# DOE/NASA TECHNICAL MEMORANDUM

## OWENS-ILLINOIS LIQUID SOLAR COLLECTOR MATERIALS ASSESSMENT

By R. L. Nichols  
Materials and Processes Laboratory

National Aeronautics and Space Administration  
George C. Marshall Space Flight Center, Alabama

Figure 5. Copper tube socket.

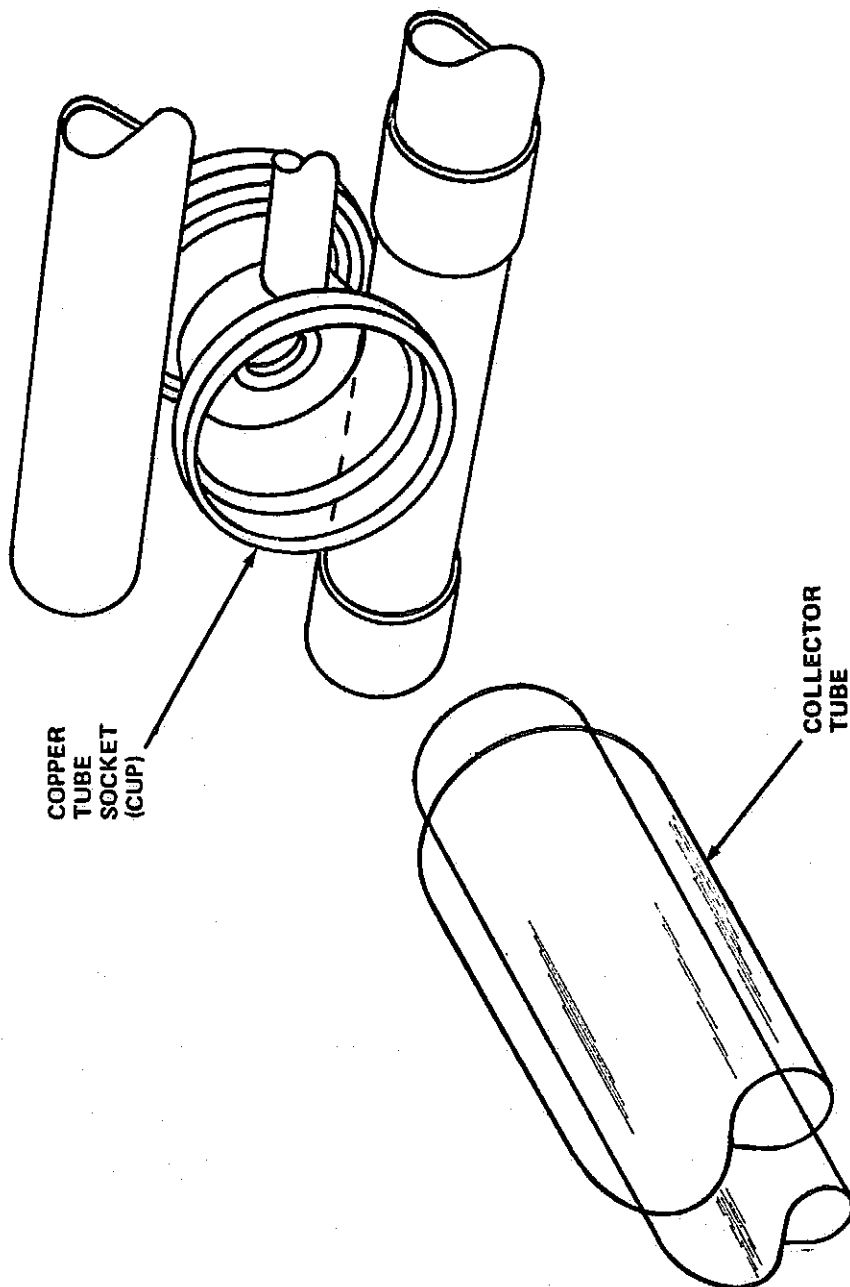
The liquid flow in the collector is channeled from one tube pair to the next by copper tubing and cups shown in Figure 5. These individual components are soldered together with Welco No. 5 solder (95 percent tin, 5 percent silver) which melts at approximately 435°F (224°C). The maximum temperature observed near a soldered component during boilout and stagnation on the solar simulator was 495°F (257°C) at the cups.

Soldering does not appear to be an adequate process for fabricating the cup assemblies. The flow of the solder, due to gravitational force, does not fill the joint as desired; the surface area in the joint is relatively small for a soldered assembly carrying loads; and the melting point of the solder is too low for the temperatures observed in stagnation/boilout.

Two alternatives are potential solutions to these problems. O-I could utilize a fully cast precision manifold where no soldered joints are necessary, or they could redesign the manifold and braze the components together. The present design does not lend itself to brazing because of the high probability of distortion due to creep and thermal expansion differences in the cups and tubing.

The solder used to assemble the manifold softens at a temperature very close to those observed during boilout conditions. The components should be brazed together provided the copper is not fully annealed during the process. The optimum manifold system would be one which is a monolithic casting. This would eliminate seal leakage and improve the tolerance achievable on the manifold.

Figure 6. Tube support cap insert.

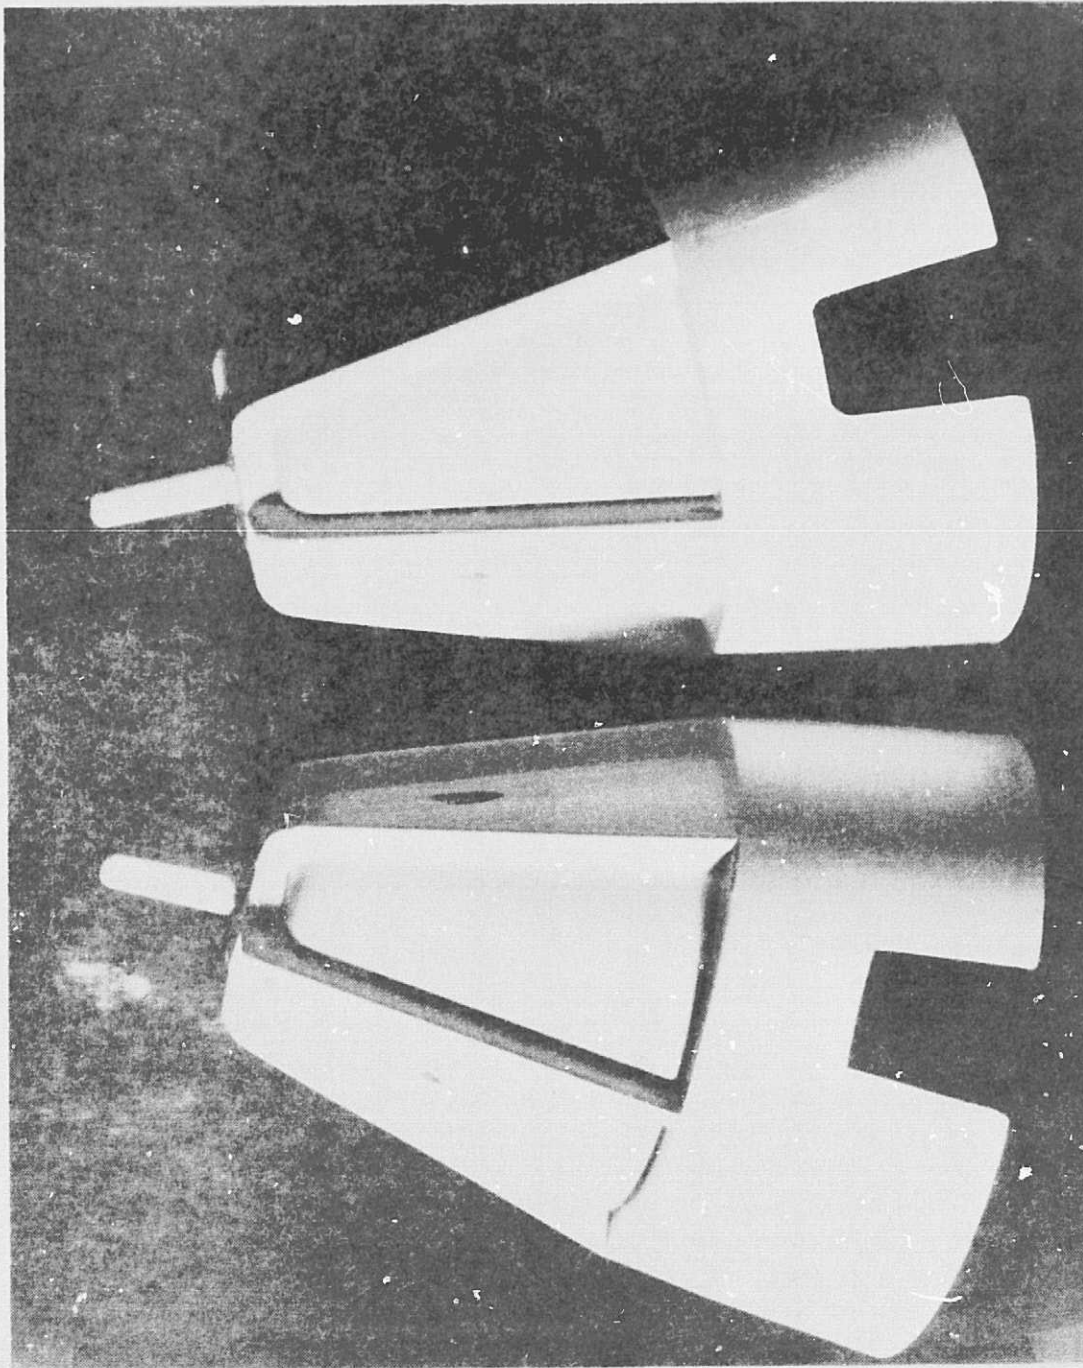
The tube support cup insert (Fig. 6) is the only plastic component identified as a potential problem area. A maximum temperature of 205°F (96°C) was observed at the position of this part. The problem encountered is deformation of the cup insert due to thermal softening during the boilout mode of collector operation. This component could be redesigned to a conical shape to improve distribution of the load transferred to it from the collector tube's closed end. Fabricating this part from a higher temperature material than acrylic-butadiene-styrene (such as polycarbonate or polysulfone) should alleviate this problem.
